UNITED STATES PATENT AND TRADEMARK OFFICE

APPLICATION NO.	FILING DATE	FIRST NAMED INVENTOR	ATTORNEY DOCKET NO.	CONFIRMATION NO.
09/752,651	12/29/2000	Robert C. Glenn	42390P9716	1502

FINAL OFFICE ACTION

Fig. 6

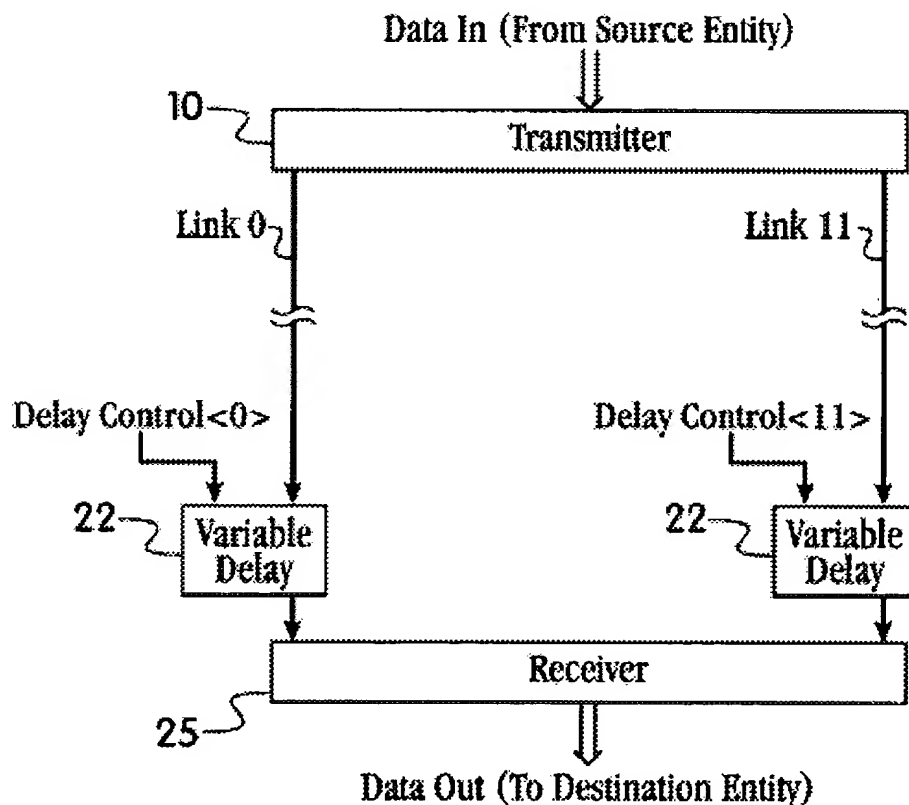
As per Claims 1-24, Widmer depicts, e.g., in Fig. 6 and related description in col. 1 line 13 et seq., the claimed method, comprising: a) measuring a skew between a data signal and a clock signal at a receiving end of a serial link; and b) adjusting (col. 2 line 27) a phase relationship between said data signal (col. 2 line 30) and said clock signal (col. 2 line 29) to reduce said skew via variable delay means implementable in hardware or software, e.g., in CPU or other digital component: Refer, e.g., to Fig. 6: block 22 and col. 2 line 23 et seq.

Widmer teaches means wherein said adjusting of said phase relationship occurs at a transmitting end of said serial link in col. 9 line 46; further comprising receiving said measured skew at a skew adjustment unit and determining said phase relationship before said adjusting a phase relationship in col. 2 line 27 and col. 10 line 23; further comprising programming said phase relationship into a semiconductor chip or IC chip in col. 9 line 27 and col. 11 line 15.

Widmer further teaches means to impose delay on one or both signals as seen in Fig. 6. And wherein said adjusting a phase relationship further comprises adjusting a phase offset between a pair of phasors associated with a pair of phase interpolators, a first of said phasors used to derive a second clock signal that times the transmission of said data signal, a second of said phasors used to derive said clock signal in col. 2 line 27 wherein equivalent means are provided for eliminating skews via multiple values of a period to effectively result in phase interpolation means. Also refer to Fig. 6 wherein variable delay blocks 22 are configured to delay signals on the links by more than 360 degrees.
